Access Compliance Report

Public Rights-of-Way

Intersection ID: 51370	Main Street: UNIVERSITY_POINTE_BV	Cross Street: IKEA_BV	Location: NE
ADA ID: C8889F508620	Ramp Type: Perp	Initial Pass/Fail: Fail	Overall Compliance: No
Severity Score: 12.5			
Codes/Mitigation Info/Possible Solution		Field Measurements/Component Compliance

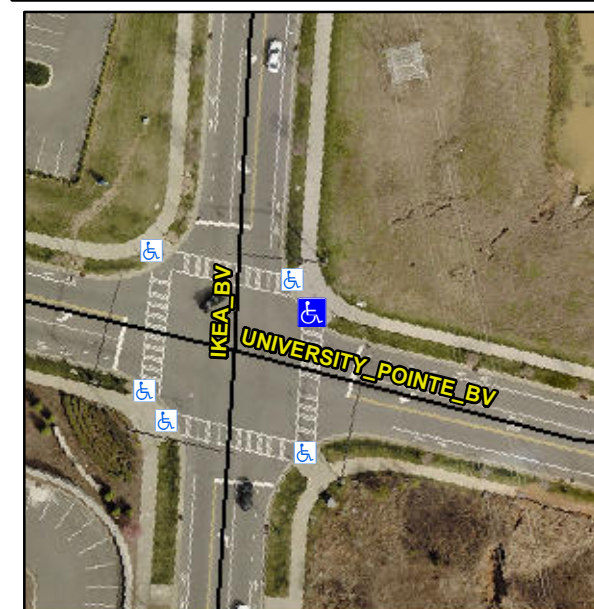
R304.2.2

Compliance	Description	Data	Compliance	Description	Data
N/A	Ramp Length (in)	96.0	No	Ramp Slope (%)	9.1
Yes	Ramp Width (in)	59.0	Yes	Ramp XSlope (%)	1.4
N/A	Flare Type LT	N/A	N/A	Flare Type RT	N/A
N/A	Flare Slope LT (%)	N/A	N/A	Flare Slope RT (%)	N/A
N/A	Flare Traversable LT?	N/A	N/A	Flare Traversable RT?	N/A
N/A	Landing Length (in)	N/A	N/A	DWS Provided?	N/A
N/A	Landing Width (in)	N/A	N/A	DWS Contrast?	N/A
N/A	Landing Slope (%)	N/A	N/A	DWS Length (in)	N/A
N/A	Landing X Slope (%)	N/A	N/A	DWS Full Width?	N/A
N/A	Landing Curb? (Y/N)	N/A	N/A	DWS Offset (in)	N/A
N/A	Shared Landing?	N/A			
N/A	Gutter Ponding?	N/A	N/A	Gutter Slope (%)	N/A
N/A	Gutter Lip Ht (in)	N/A	N/A	Gutter X Slope (%)	N/A
N/A	Painted X Walk1?	Yes	N/A	Painted X Walk2?	N/A
	X Walk 1 Direction	To S		X Walk 2 Direction	N/A
N/A	X Walk 1 Width (in)	112.0	N/A	X Walk 2 Width (in)	N/A
	X Walk 1 Slope (%)	3.8		X Walk 2 Slope (%)	N/A
	X Walk 1 X Slope (%)	3.9		X Walk 2 X Slope (%)	N/A

Remove & Replace Entire Ramp.
